The property located at 611 West 98th Street shall comprise the boundaries for this USD.

The property will have a newly built Bank of America located within its boundaries. This building will utilize wall signage, freestanding signage, and informational signage throughout the property. Details of all signage on the property are listed within this USD. Please see attached prints for exact locations and specific details for each sign:

APPROVED
Zoning Review Only
04/20/2021 NMJ

CASE #PL2021-72

PRIMARY ELEVATION (EAST)

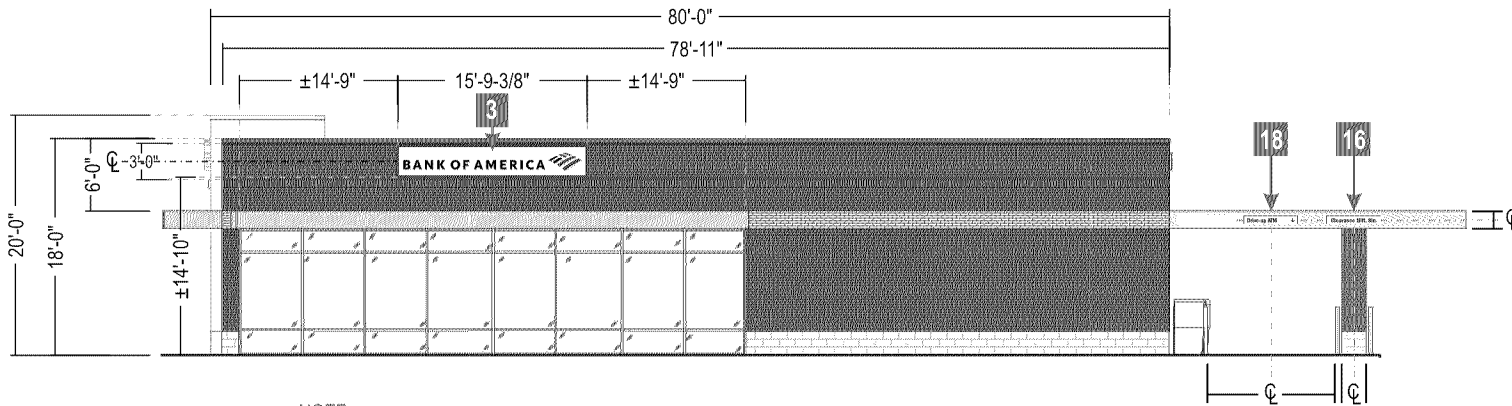
NOTE:
SIGN AREA CALCULATIONS
18'-0" HEIGHT x 53'-0" WIDTH = 954 SQFT
~~1100 SQ FT - 12% ALLOWED BY CODE = 124 MAXIMUM SQ FT~~
8% allowed = 76 square feet

SECONDARY ELEVATION (NORTH)

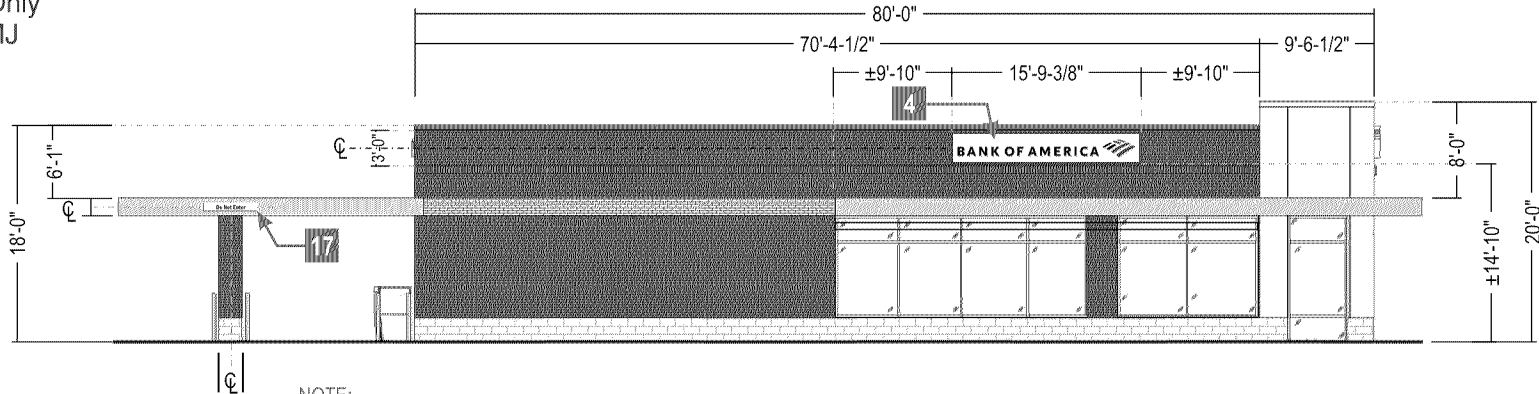
NOTE:
SIGN AREA CALCULATIONS
18'-0" HEIGHT x 80'-0" WIDTH = 1440 SQ FT FACIA
~~1100 SQ FT - 12% ALLOWED BY CODE = 124 MAXIMUM SQ FT~~
4% allowed = 58 square feet

SECONDARY ELEVATION (SOUTH) 4% allowed= 58 square feet

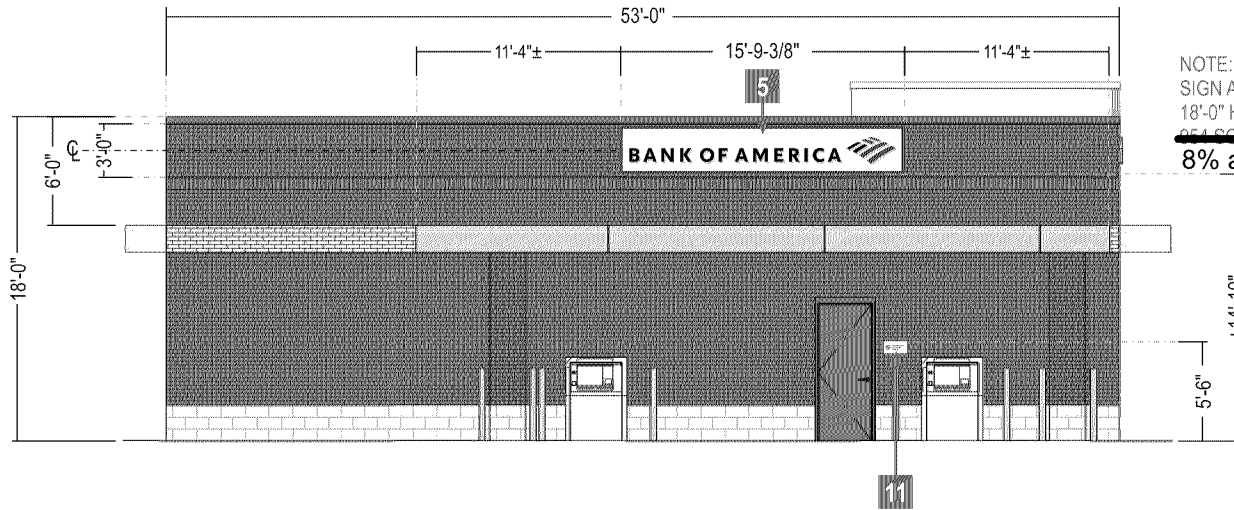
NOTE:
SIGN AREA CALCULATIONS
18'-0" HEIGHT x 80'-0" WIDTH = 1440 SQ FT FACIA
~~1440 SQ FT x 40% ALLOWED BY CODE = 576 MAXIMUM SQ FT~~
